**Application of Pennsylvania-American Water Company for the Acquisition of  
the Wastewater Treatment Plant and Collection System Owned and Operated by  
Elizabeth Borough Municipal Authority (“EBMA”)  
Docket No. A-2023-3038717**

**66 Pa. C.S. § 1329  
Application Filing Checklist – Water/Wastewater**

RE: Elizabeth Borough Municipal Authority  
 Act 537 Sewage Facilities Plan Update  
 SENATE # 11956

The following is in response to the comments provided in your letter dated October 17, 2017 regarding the Elizabeth Borough Municipal Authority (EBMA) Long Term Control Plan (LTCP). The LTCP was submitted to Pennsylvania Department of Environmental Protection (DEP) in July 2017. Each DEP comment in the letter is listed below with the response.

# Preliminary Site Plan

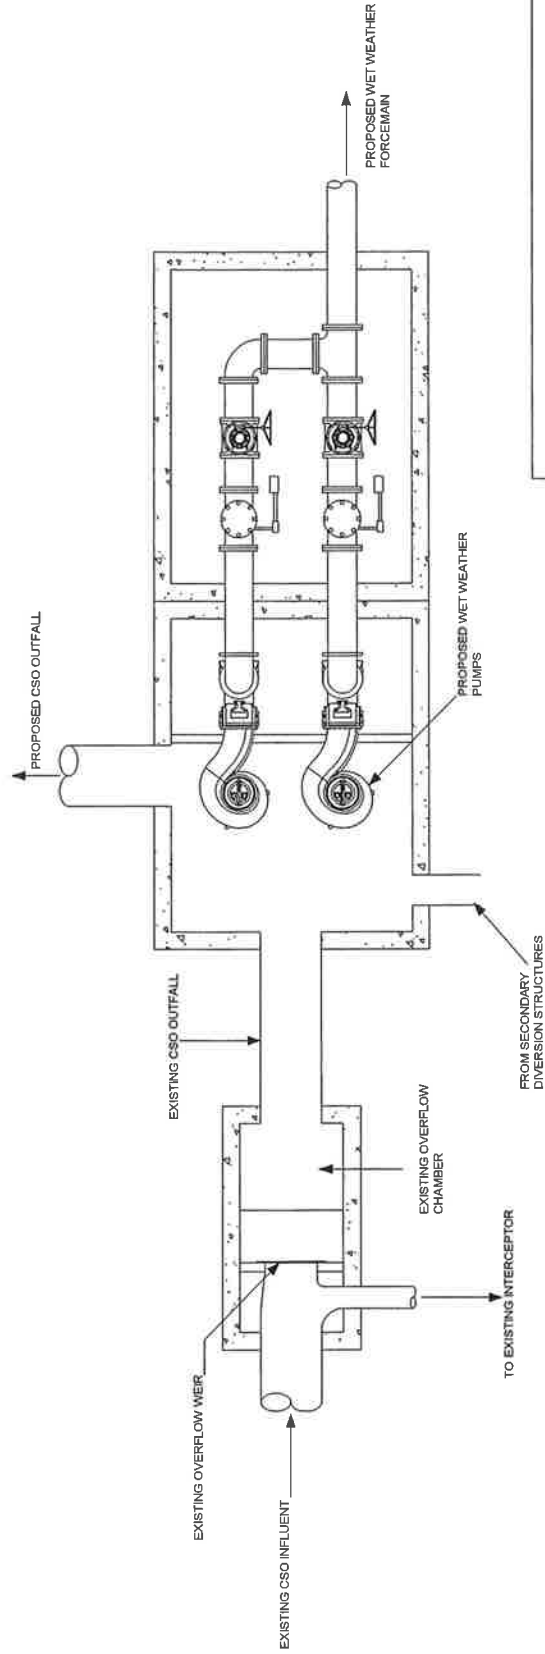
**5. Provide a summary and available drawing details of the reconstruction proposals for the gravity portion of the Fallen Timber Run interceptor.**

Reference the response to Number 2 for a detailed description of the proposed pump station and Fallen Timber Run relocation. See the attached Preliminary Site Plan for the proposed Fallen Timber run and pump station layout.

### Fallen Timber 3 Month Event

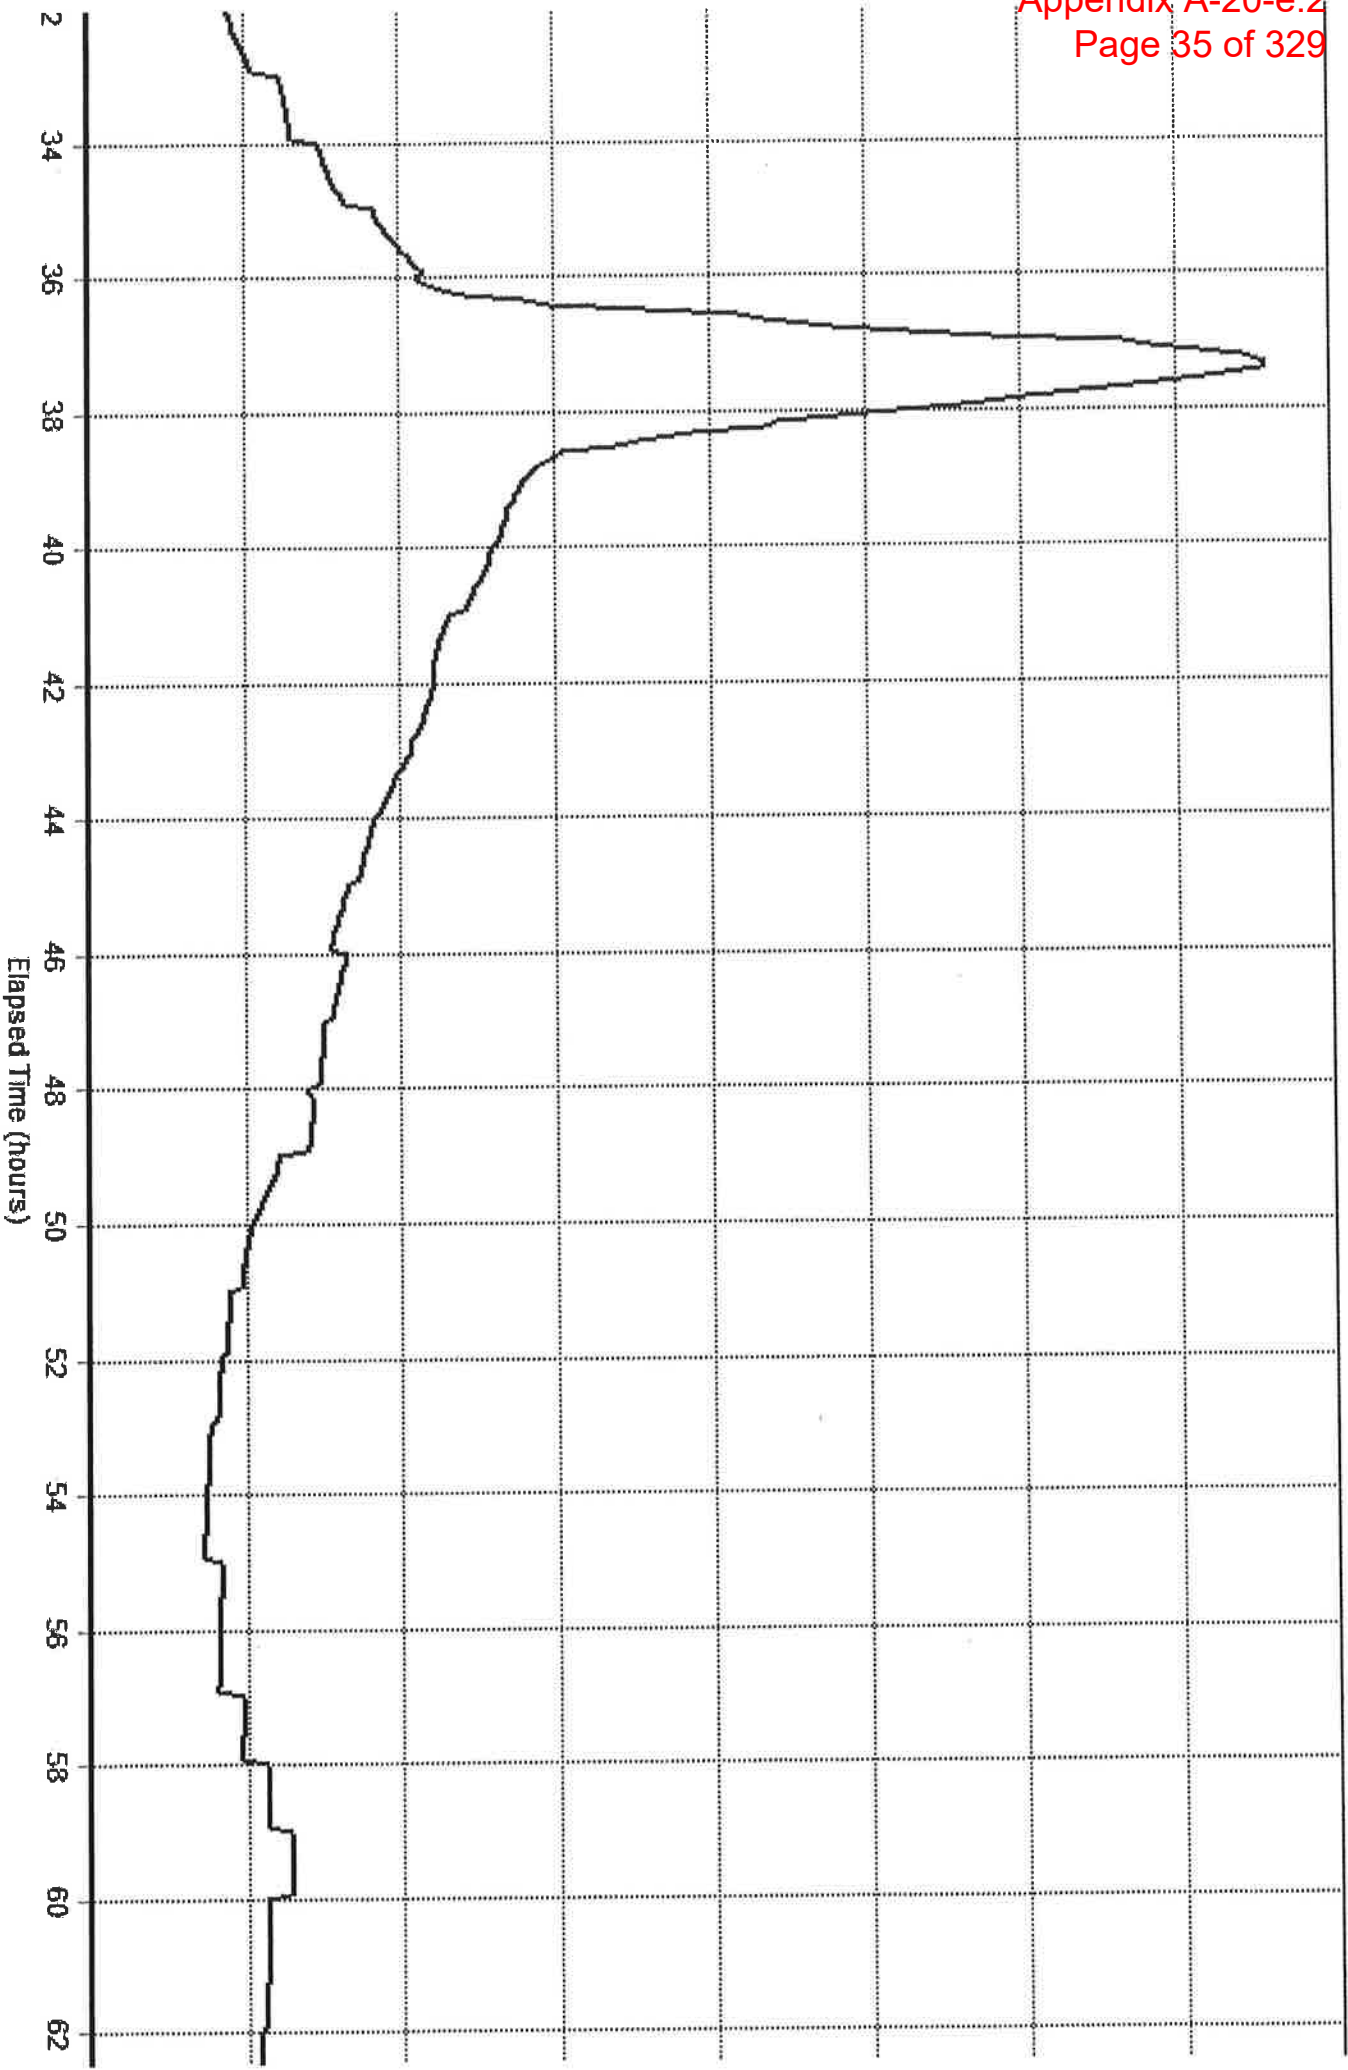
no y-axis?  
units.
